HOUSTON PLANNING COMMISSION

AGENDA

JULY 11, 2019

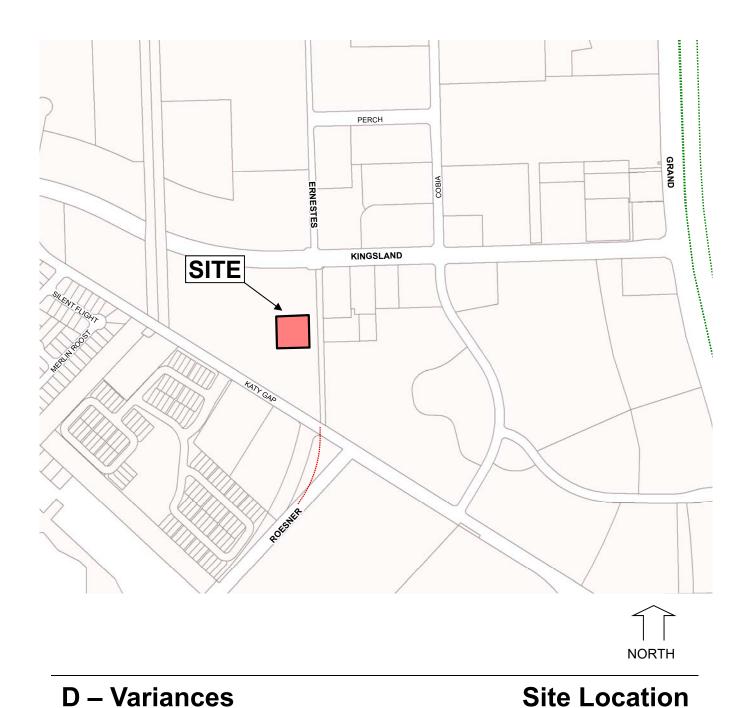
Make corrections and additions as indicated by Harris County's marked file copy on City of Houston's plat tracker. (HC)

Developer will be required to dedicate 50 feet of ROW for the western half of Ernstes, build half boulevard section and account for drainage for full 100 foot section when remainder of tract develops after water plant

Temporary easement will need to be recorded by separate instrument prior to plat recordation County has no objections to variance.

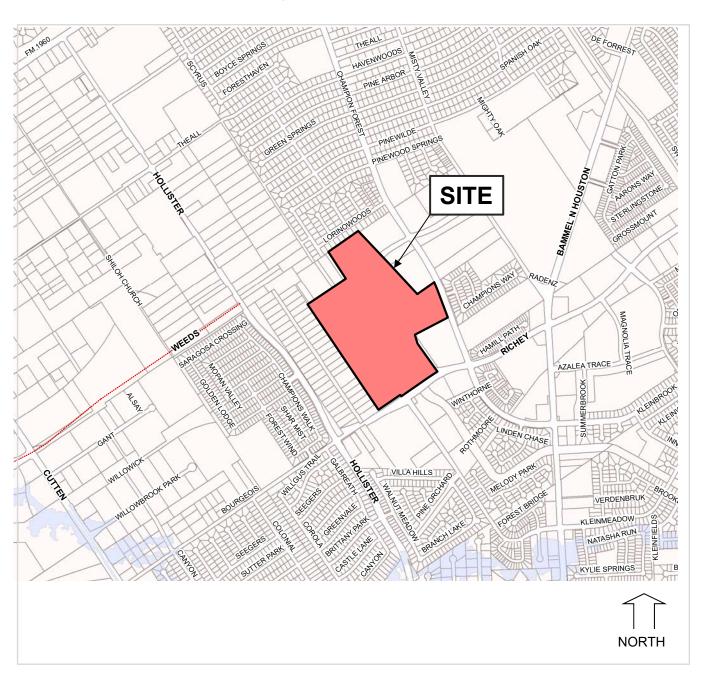
Entry private road should be relocated to be C/L tied with Bourgeois Road.

EB left turn lane will be required on West Richey Road at relocated private entry road and NB left turn lane will be required on Champion Forest Drive at private entry road.

Private entry road should be C/L tied with Champion Forest Lane across Champion Forest Drive.
